AGENDA

PLANNING & ZONING COMMISSION REGULAR MEETING TUESDAY, SEPTEMBER 1, 2020 - 3:30 PM MCALLEN CITY HALL, 1300 HOUSTON AVENUE CITY COMMISSION CHAMBERS, 3RD FLOOR Web: <u>https://zoom.us/join</u> or phone: (346) 248-7799 Meeting ID: 672 423 1883

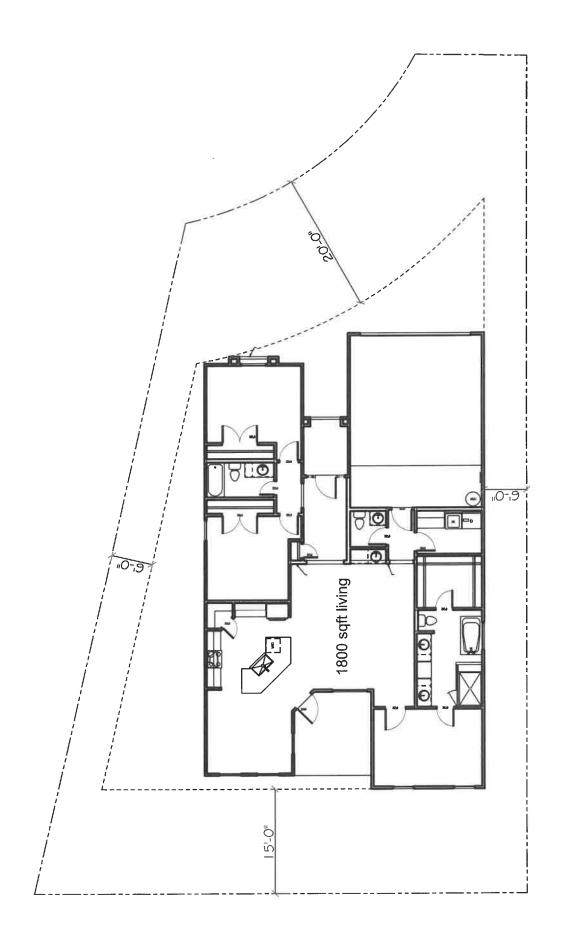
We are respectfully requesting to modify the double fronting lots rear setback along N 29^{TH} Street (Lots 1 -6; 48-53) from 25 ft to 15 ft.

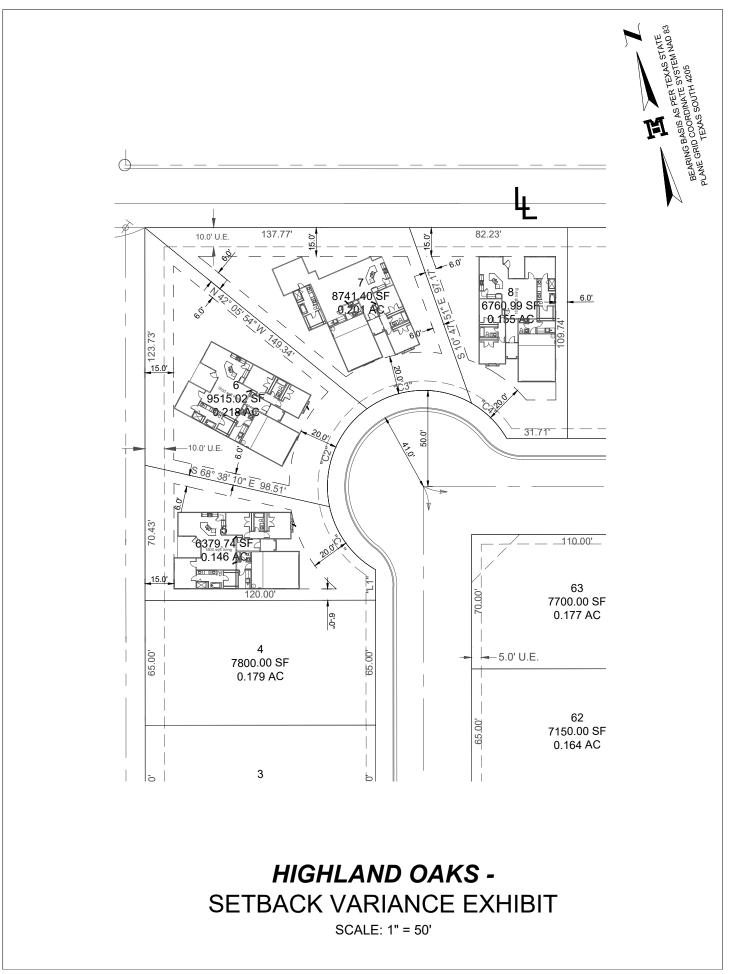
In addition, we would like to request front setbacks at all the cul-de-sac lots (Lot 5-8; 20-23; 32-35; 46-49) to be reduced from 25 feet to 20 feet.
